Product Change Notification

ITT Cannon

PCN Number: PCN26003WN

192990-0350 – Trident Snap Together (TST) Plug 2-way

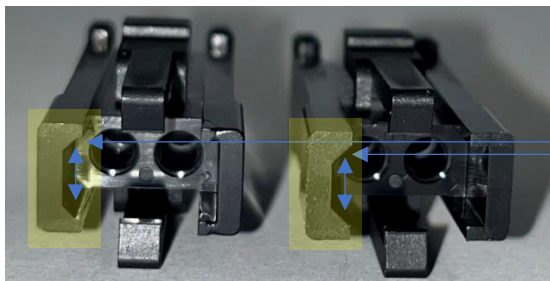
This letter is to inform you about changes we have already done in 2024. We have improved the profile/geometry of the connectors to eliminate incorrect mating.

There was a possibility of reverse assembly. The connector was possible to mate either way, even these connectors have a profile/geometry (see yellow marking) to ensure the plug and receptacle is mated the correct way.

Left side: Old version

Right side: New version with
corrected angle and longer slope.
